**LATHAN · McKEE**  
ARCHITECTS

**ADDENDUM NO. 1**  
**ELEVATOR REPLACEMENT AT TALLADEGA COUNTY BOARD OFFICE**  
**Architect Job No. 25-96**  
**Bid No. 1817**  
**June 16, 2026**  
**DCM #2026399**

SHEET TITLE:  
ELECTRICAL PLAN

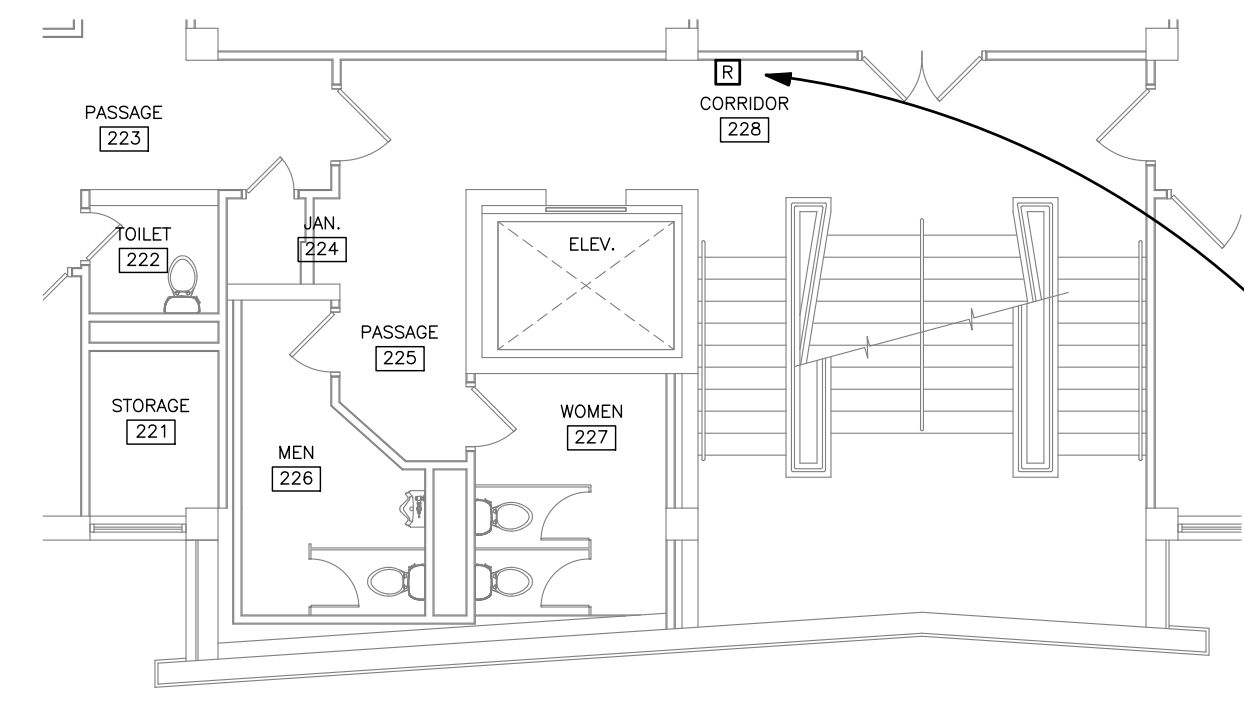
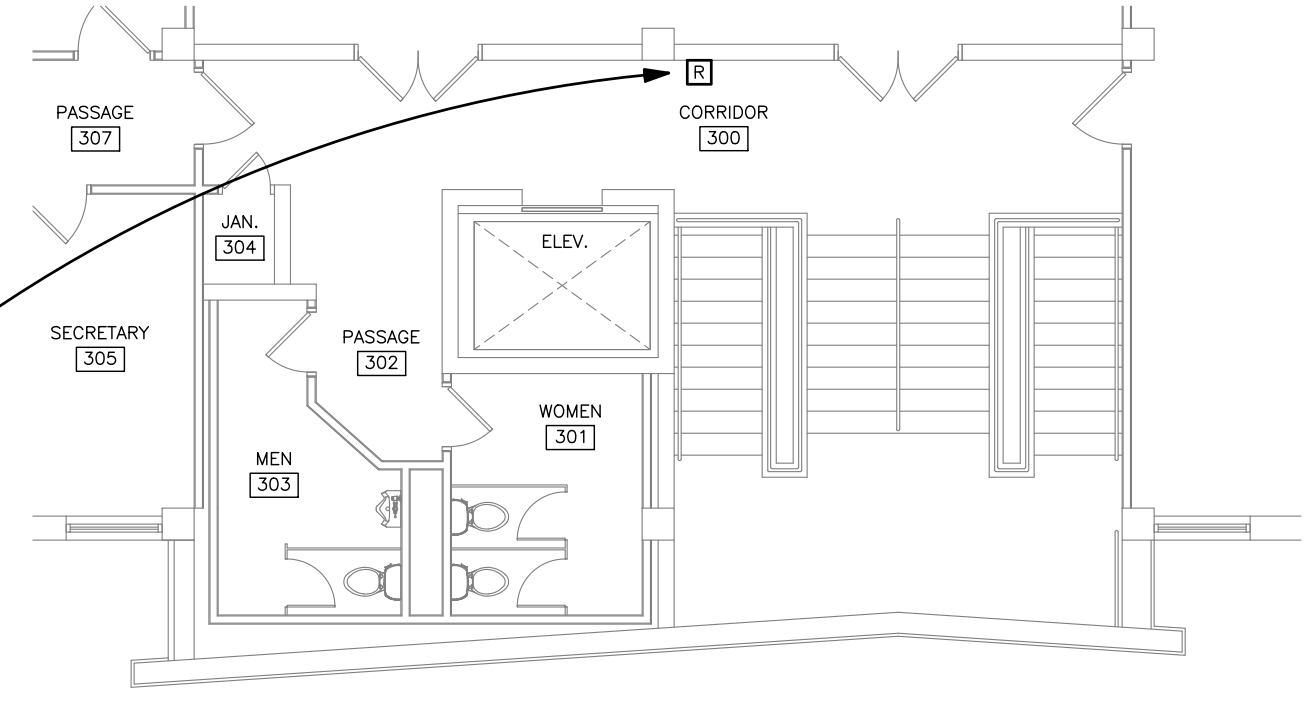
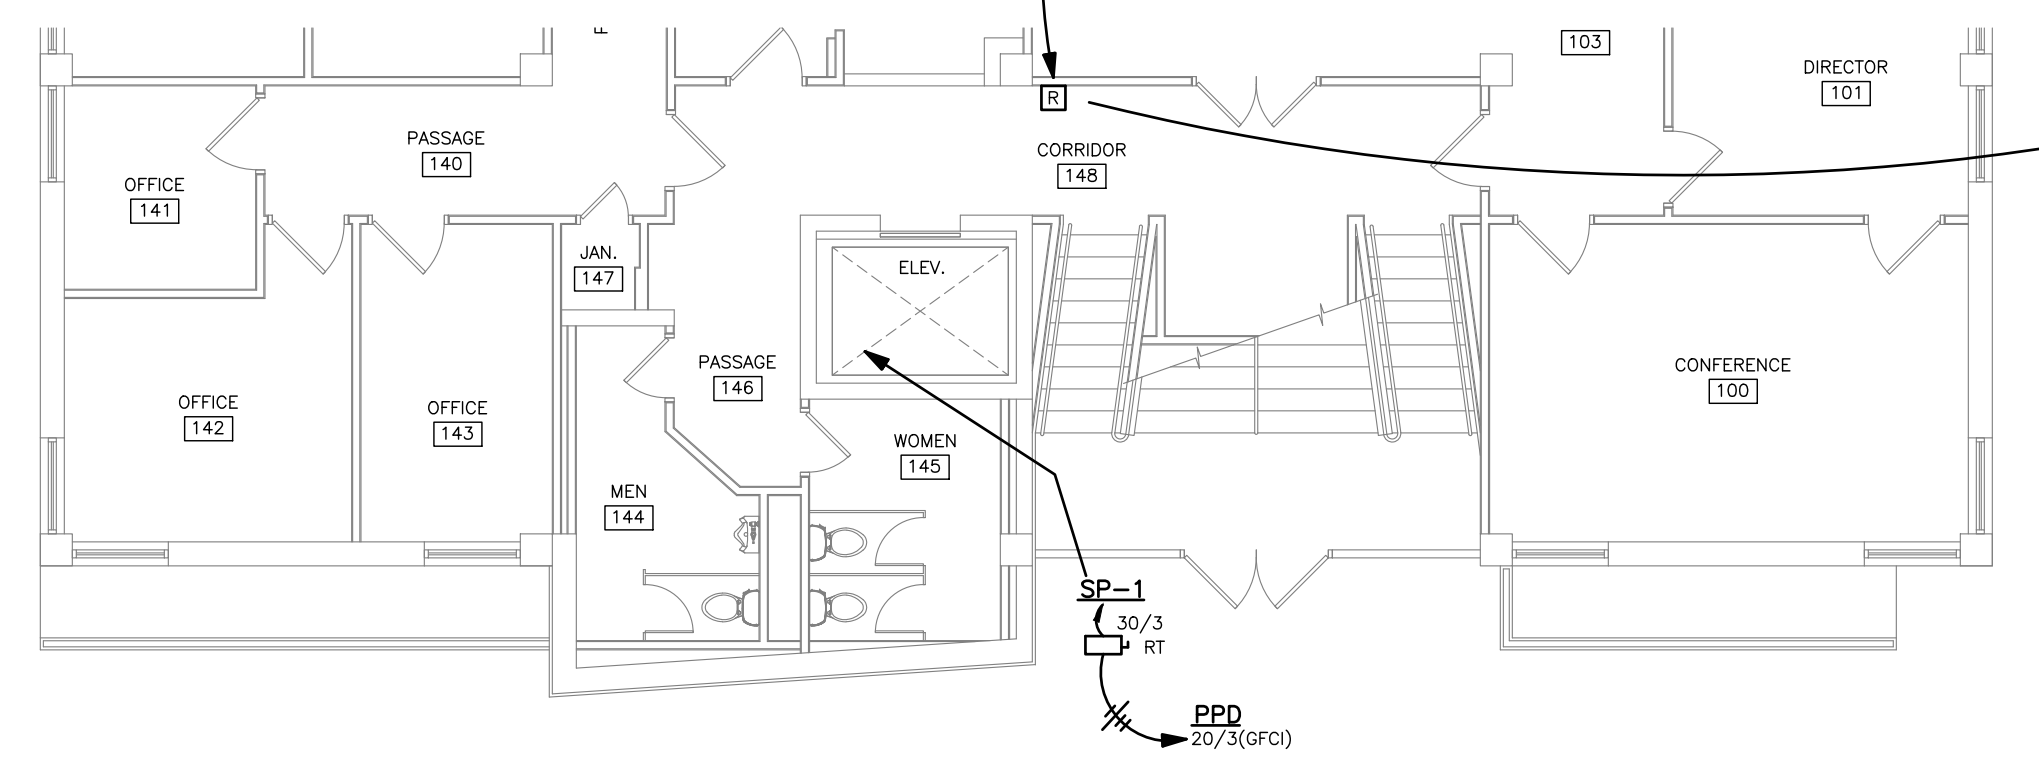
1. **Sheet E1.1 – Electrical Plan:** Revised to change the breaker for sump pump to be GFCI breaker.
